City of Plymouth Plan Commission

The City of Plymouth Plan Commission will have a meeting on **Thursday, March 6, 2025 at** 6:00 PM in **Room 305**, City Hall, and Plymouth, WI.

RE: Conditional Use Permit Seeking Approval: 2831 Eastern Avenue, Plankview

Site Plan Seeking Approval; 2831 Eastern Avenue, Plankview Green Development, LLC (dba North Town Partners) regarding proposed site plan improvements and construction of two multi-family dwellings of 54 and 51 units each for residents aged 55 and over. North Town Partners/Merklein (enclosure)

CIVIL SITE PLAN

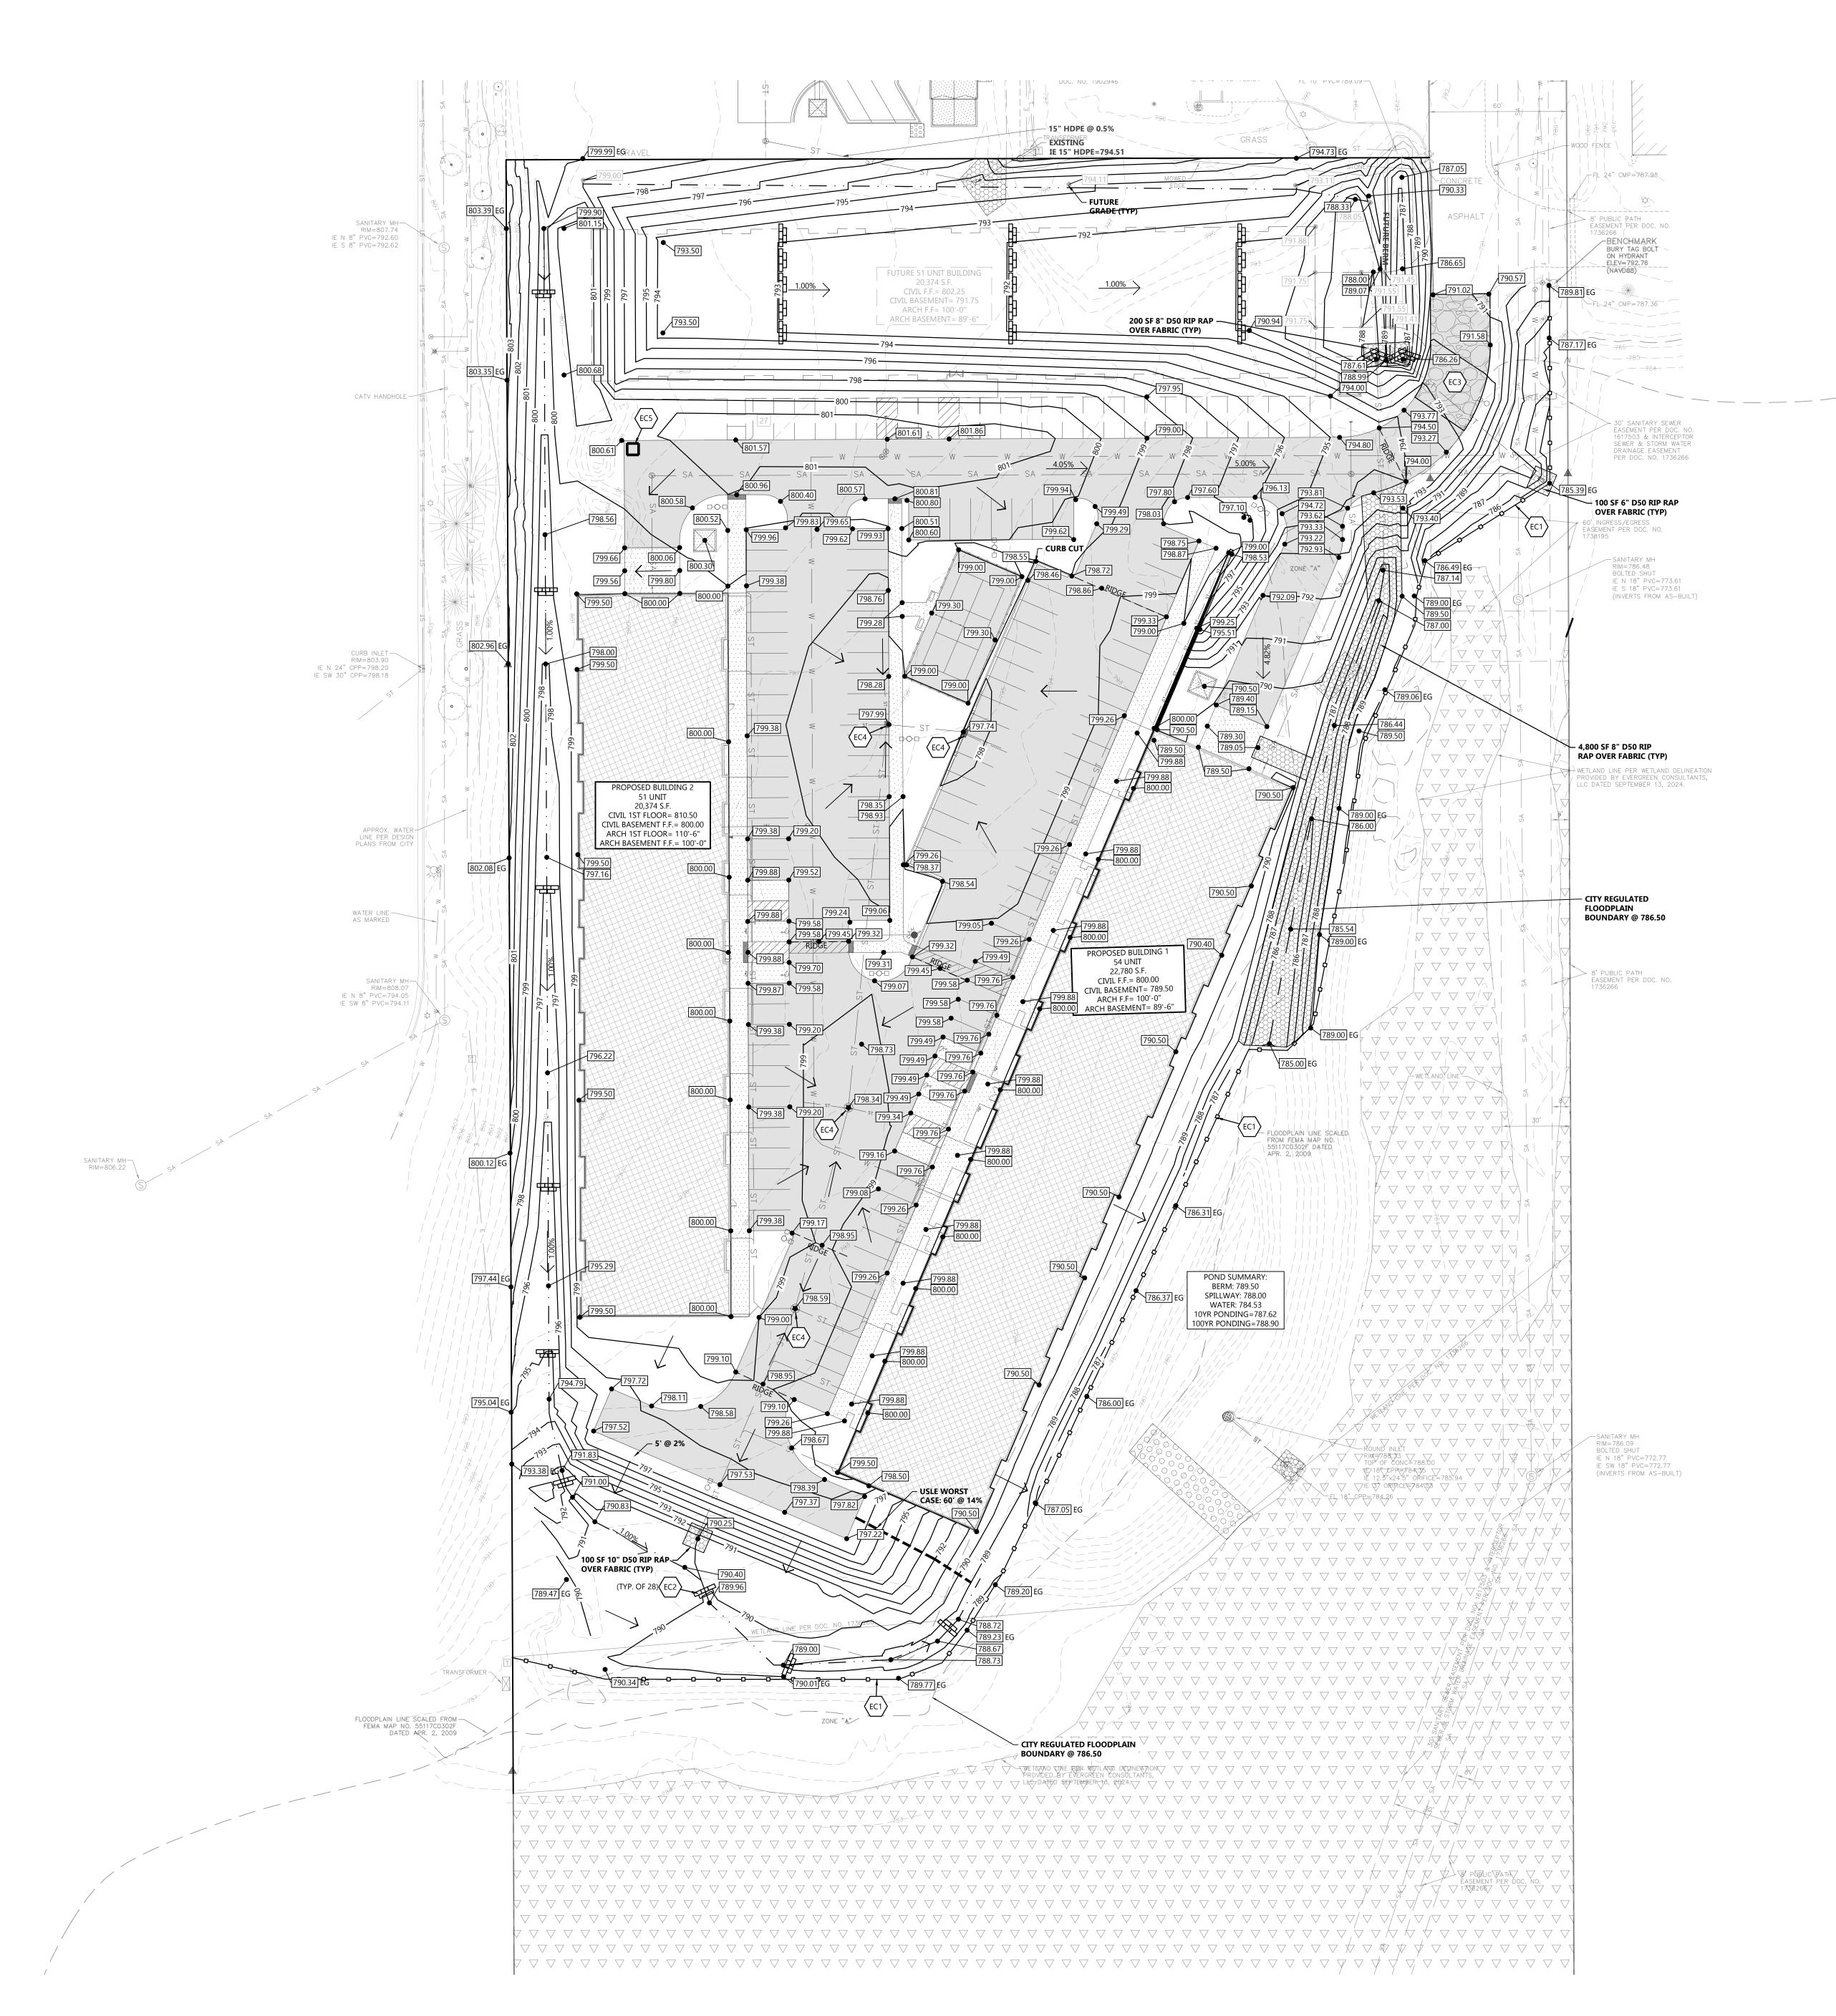
City staff has provided the zoning matrix below that indicates no issues with the site plan in respect to setbacks in R-6, building heights, lot coverage, and lot width.

All buildings will have underground parking for residents in addition to surface parking lot spaces for residents and visitors. The submitted site plan indicates Phase 1 of the development (southern two buildings) will contain 230 parking spaces (120 surface parking spaces and 110 underground parking spaces) Phase 2 of the development currently contains 27 additional surface parking lot spaces and 50 underground parking spaces. City Code requires a minimum of 1.5 spaces per dwelling unit in R-6 meaning that Phase 1 would require 156 total parking spaces. The submitted site plan indicates that Code requirements for parking are met for Phase 1. When including Phase 2 of the development, City Code would require 234 parking spaces. The submitted site plan appears to be in adherence with code requirements for off-street parking.

CIVIL UTILITY PLAN

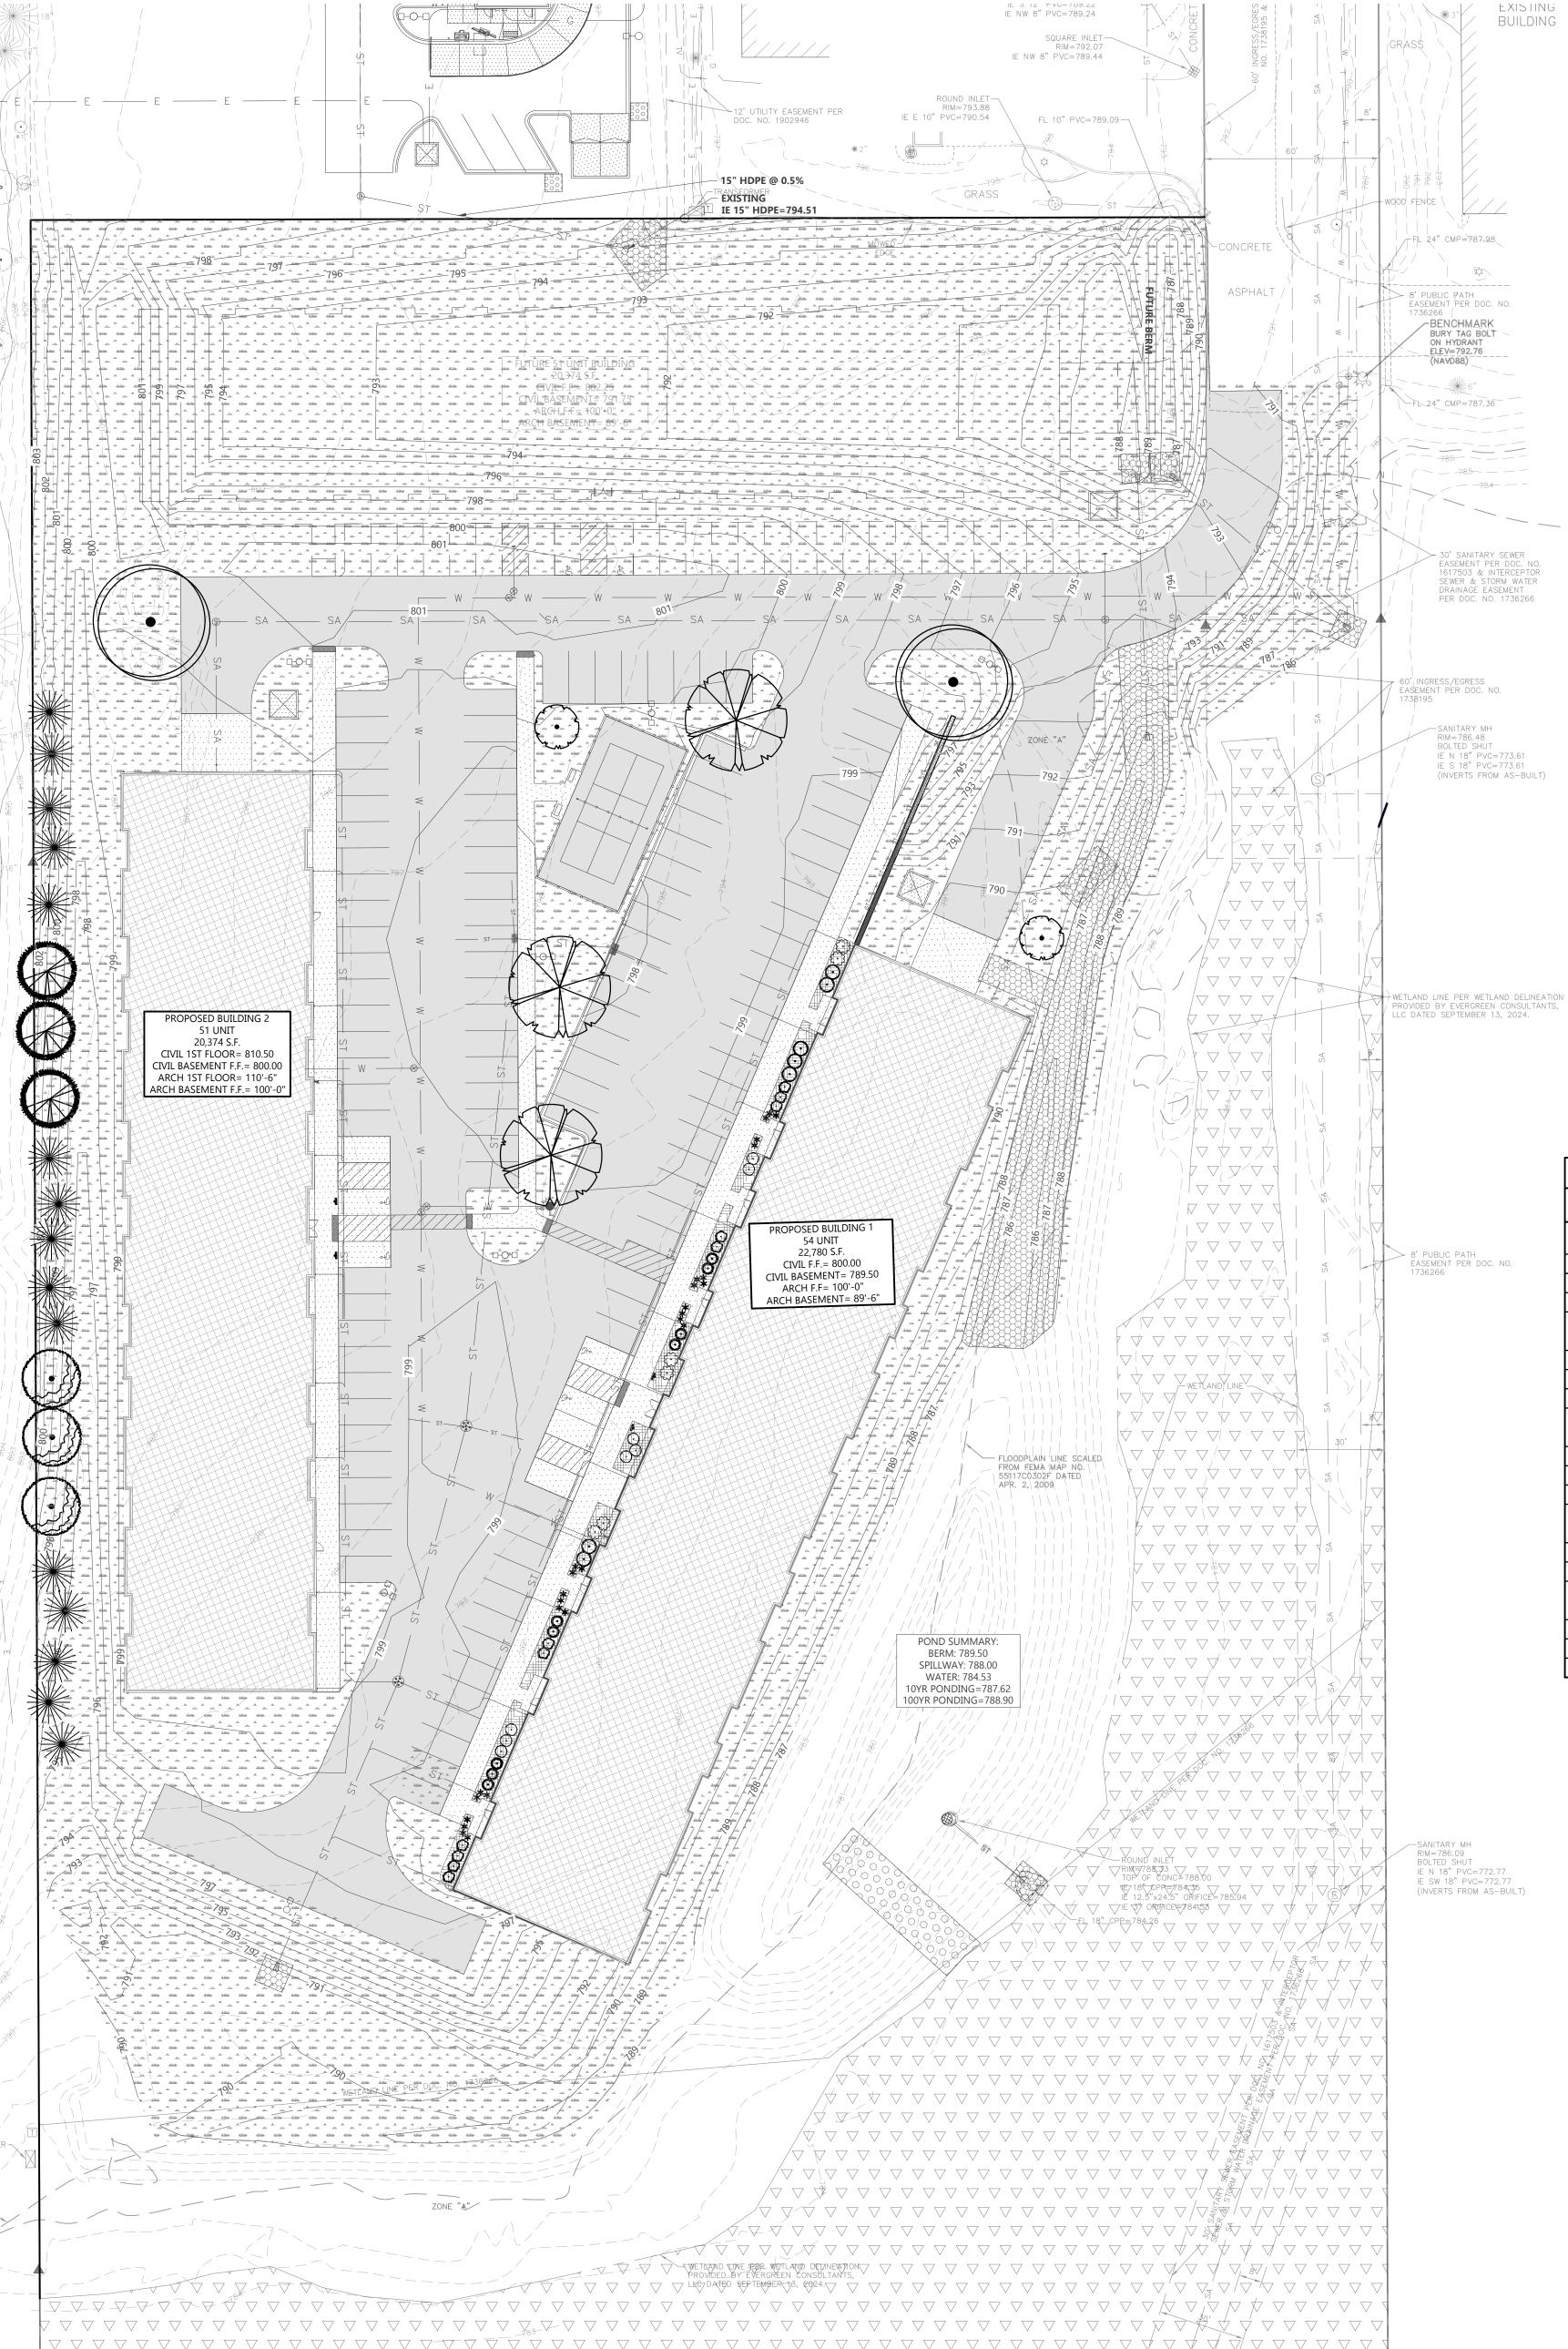
- The watermain is private.
- o The proposed connection to the municipal system meets requirements.
- Submit flow data for each building so the Water Utility can ensure proper water meter size.
- o Investigate where the water will flow when the new hydrant is flushed.
- Is the plan to have one (1) water meter per building or will each unit be individually metered? If individual, please submit actual plumbing plans so we can ensure that proper space in the maintenance room is given.

- The proposed stormwater management plan complies with city requirements. The pond was constructed in 2023 and designed to handle this development.
- The developer must submit a stormwater maintenance agreement for the detention basin to ensure long-term compliance with maintenance responsibilities. City has sent a draft of the agreement to Excel Engineering.
